HISTORIC PRESERVATION DESIGN REVIEW

HP-08-13 (Rev. 1), 315 W. Calhoun St. (317) (City)

The applicant is requesting Historic Preservation Design Review approval to amend the original approved plans (HP-08-13) for property located at 315 (317) W. Calhoun St. and represented by Tax Map # 228-06-03-070 (p).

Left side of entry from W. Calhoun St.

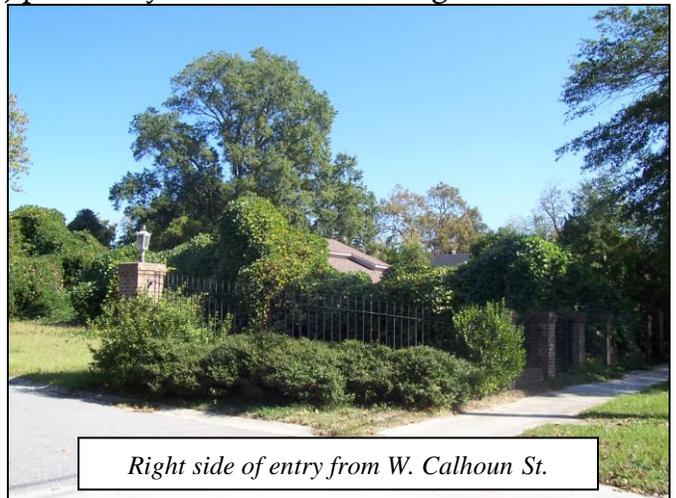
These two structures went through design review prior to the adoption of the current guidelines manual and more closely resemble contemporary residential structures found in a subdivision rather than in the Hampton Park District. Since the original development plan, new guidelines have been adopted that emphasize design standards more compatible with the existing character of Hampton Park.

The following elevations show the primary facade and visible secondary façade for the proposed design under review.

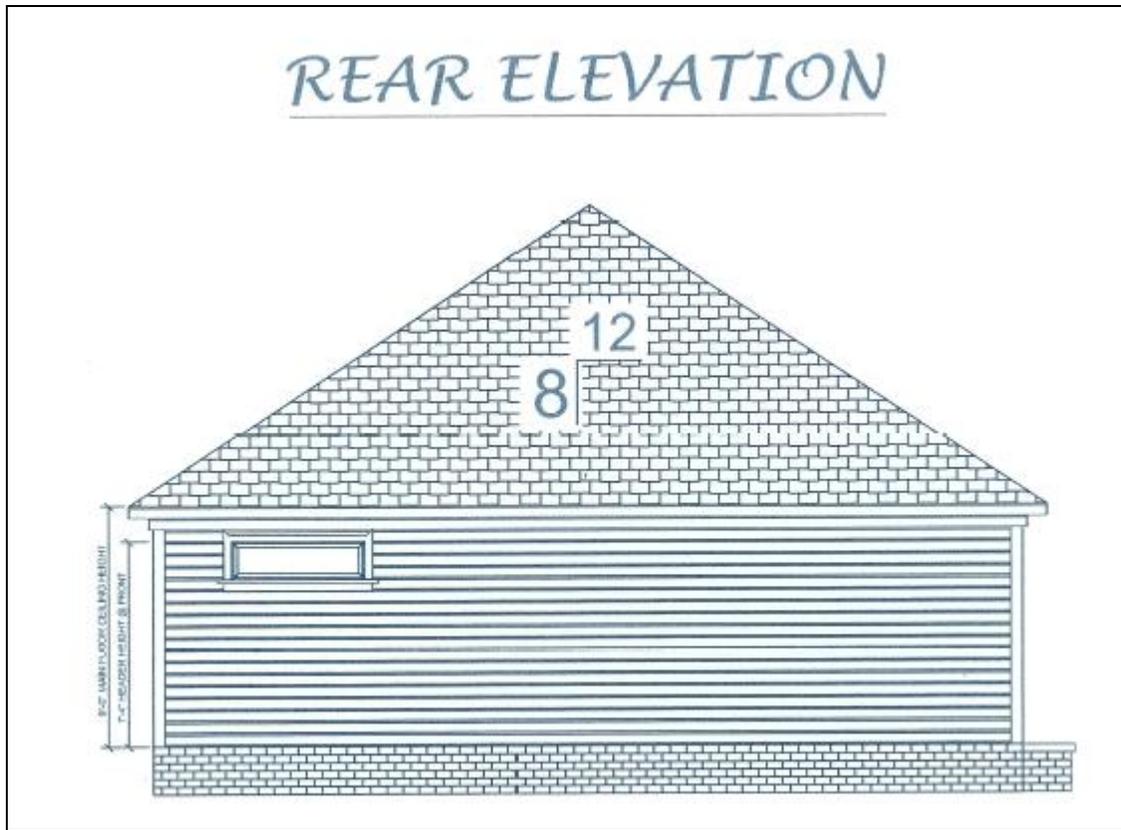
The proposed structure has cross-gable ends with vertical and horizontal siding, 4-over-4 side by side window configuration, cottage-style shutters, traditional front door with transom and front/side wrap-around porch with Craftsman-style detailing in the brick pillars and battered columnar supports. Proposed roofing material will be black architectural shingles. The proposed siding will be fiber cement siding with embedded color in a green that is chosen from the approved residential palette. The foundations will be constructed of red brick on a crawlspace. The rear elevation shown on the next page continues with horizontal lap siding and features a single paned window on the left side.

The left side as shown below will be oriented towards Calhoun Place. It features a recessed screen-porch entrance and hipped roof. The more contemporary elements such as the attached garage will not be readily visible to passing traffic from W. Calhoun St. and the design is in keeping with the structures already in place on this City-owned street.

The submitted renderings show the brick foundation is a minimum of 1 ft. in height on the primary and secondary façades.

Based on submitted renderings and site visits, the proposed structures will be compatible with the adjacent structures. This structure will have a ceiling height of nine (9') feet.

The proposed structure has porches on both the front and side façades that have been designed and placed to be compatible with buildings in the neighborhood.
